CONSTRUCTION SUMMARY

132 - 4 - The Rideau 6 (42-6) Elev C Opt 5 Bed

Bayview Wellington				
Purchaser:	QIU LAN LIANG	Pro	perty: 132	
Telephone Res. / Bus:	(647) 703-6858 /			Capital Holdings Inc.
Decor Advisor:	Inna Semikolenniha		-	u 6 (42-6) Elev C Opt 5 Bed
Lock Date:	6-Jun-17	6-Jun-17	Plan #:	51M-1063
_	_			
Layout Changes: Y		Attached: Yes No	Exterior Colour	Scheme: # 2

NEW RIDEAU-6 Rot Ba (2' SIngles OPT WAFFLE CEILING GREAT ROOM 18'0"x12'0" 1 BREAKFAST (QLL) Jaky Becil LIVING/DINING 13'0"x21'6" JTCHEN 135"x10'6" chimney (KIH) J20 electrons micro oven Jobl STUDY 13'5'x10'6' FRENCH DOORS STORAGE MUD (P) SUNKEN FOYER RU GARA 187 PORCH Ground Floor Elevation A

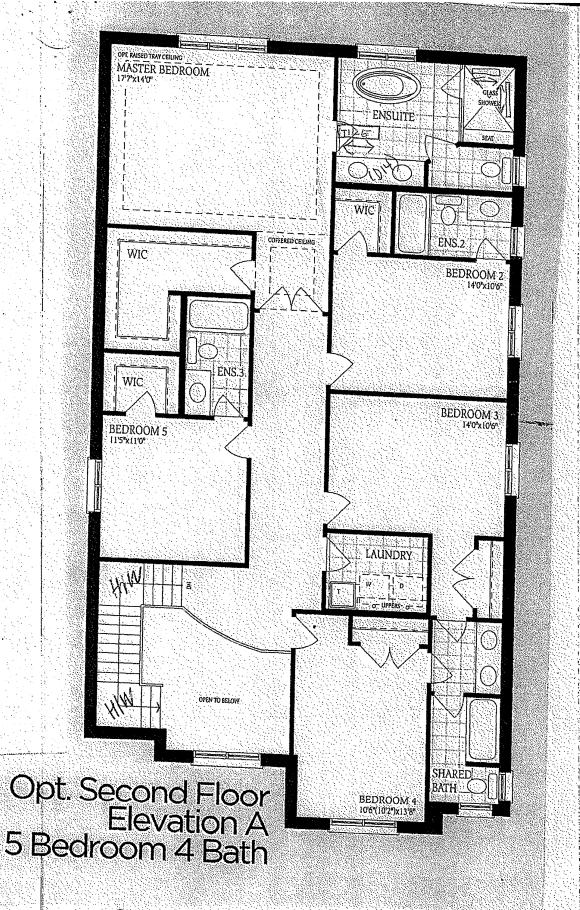
Inv.1,864 1 - DELETE PORTION OF PANTRY LEAVING FRIDGE OPENING TO ACCOMODATE BUILT Line18670 Note: PURCHASER RELOCATING 2.5' PANTRY TO DISHWASHER.	
DISTIWASTILK.	OPPSITE SIDE OF KITCHEN ACROSS FROM
23May17 / 25Oct17	
Inv.1,864 1 - CABINETRY - KITCHEN - GROUP 3 VIKIN	G 3
Line18659 Note:	
23May17 / 25Oct17	
Inv.1,864 1 - (K14) FASCIA CEILING PANELS FOR CRO CROWN MOULDINGS)	WN MOLDING (PRICE INCLUDES STANDARD
Line 18661 Note:	
23May17 / 25Oct17	
Inv.1,864 1 - DELETE CABINETRY ABOVE STOVE TO	ACCOMODATE A 36" CHOMENY HOOD FAN
Line 18674 Note:	
23May17 / 25Oct17	
Inv.1,864 1 - VANITY - ENSUITE BATHROOM - GROUP	3 VIKING 3
Line18676 Note:	
23May17 / 25Oct17	
Inv.1,864 1 - VALANCE CABINETRY THROUGHOUT K	TCHEN
Line 18680 Note:	
23May17 / 25Oct17	
Inv.1,864 1 - VANITY - SHARED BATHROOM - GROUP	3 VIKING 3
Line18688 Note:	
23May17 / 25Oct17	
Inv.1,864 1 - VANITY - ENSUITE BATHROOM 3 - GROU	P 3 VIKING 3
Line 18689 Note:	
23May17 / 25Oct17

Inv.1,864	
Inv.1,864	D BUILT IN
Inv.1,864	
REQUIRED, PURCHASER TO SUPPLY SPECS	
23May17 / 25Oct17	RIMKIT
Inv.1,864 1 - (J33) COOKTOP CABINET WITH FALSE TOP DRAWER AND POTS&PANS DRABELOW (PURCHASER TO SUPPLY SPECS) 36" OVEN - SPECS TO BE PROVIDED Line18673 Note: 1 - RELOCATE COOKTOP TO BE CENTRED WITH 4X7 ISLAND - AS PER SKETCH Line19170 Note: ++++++++++++++++++++++++++++++++++++	
BELOW (PURCHASER TO SUPPLY SPECS) 36" OVEN - SPECS TO BE PROVIDED Line18673 Note: 1 - RELOCATE COOKTOP TO BE CENTRED WITH 4X7 ISLAND - AS PER SKETCH Line19170 Note: ++++++++++++++++++++++++++++++++++++	
23May17 / 25Oct17 Inv. 1,864 1 - RELOCATE COOKTOP TO BE CENTRED WITH 4X7 ISLAND - AS PER SKETCH Line 19170 Note: ++++++++++++++++++++++++++++++++++++	RAWERS
Inv.1,864 1 - RELOCATE COOKTOP TO BE CENTRED WITH 4X7 ISLAND - AS PER SKETCH Line19170 Note: ++++++++++++++++++++++++++++++++++++	
Line19170 Note: ++++++++++++++++++++++++++++++++++++

++++++++++++	СН
23May17 / 25Oct17	AND
CABINETRY - BASE CABINETS	
Inv.1,864 2 - (B01) BASE CABINET PER FOOT - ADD 2 FEET OF BASE CABINETRY ALONG STOVE WALL - AS PER SKETCH	NG PERIMETER
Line18666 Note:

Inv. 1,864	2 - (A01) UPPER CABINET PER FOOT
	ADD 2 FEET OF UPPER CABINETRY ALONG PERIMETER STOVE WALL - AS PER SKETCH
Line 18665	Note:
23May17 / 25Oct17

Inv. 1,438	1 - DELETE WALL AS PER SKETCH #1 AND SKETCH #2
	2' -6" (as per sketch #1) REQUIRED TO REMAIN - DROPPED STEEL BEAM AND BULKHEAD REQUIRED
Line15554	Note:
14Nov16 / 17Apr17

Inv. 1,438	1 - ICE MAKER ROUGH IN - WATERLINE TO FRIDGE FOR ICEMAKER
Line 15570	Note:
14Nov16 / 17Apr17	
Inv. 1,864	1 - TURN EXISTING PINNISULA INTO A 4 X 7 ISLAND (B3x7)
	ELECTRICAL PLUG REQUIRED
	ALIGHN ISLAND WITH EXTERIOR WALL CABINETS
Line 18662	Note: PLEASE LEAVE 3.5 FEET SPACE BETWEEN ISLAND AND WALL WITH COOKTOP CABINETRY - ENSURE LENGTH OF ISLAND IS ALIGNED WITH PERIMETER CABINETS
23May17 / 25Oct17	
Inv. 1,864	1 - PLEASE LEAVE 3.5 FEET SPACE BETWEEN ISLAND AND WALL WITH COOKTOP
	CABINETRY - ENSURE LENGTH OF ISLAND IS ALIGNED WITH PERIMETER CABINETS
Line 20497	Note:
23May17 / 25Oct17

RIDEAU-6
Eler-C 5BdCR

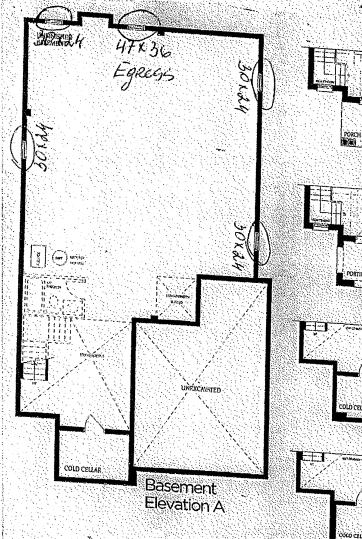
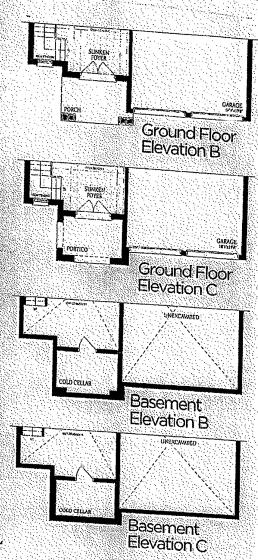
14Nov16 / 17Apr17	
Line 15573	Note: 4 X WINDOWS TO BE INCREASED.
Inv. 1,438	4 - BASEMENT WINDOW - 30 X 24 AS PER SKETCH
14Nov16 / 17Apr17	
Line15572	Note: 1X WINDOW TO BE INCREASED
Inv. 1,438	1 - BASEMENT WINDOW - 47 X 36 - EGRESS WINDOW AS PER SKETCH
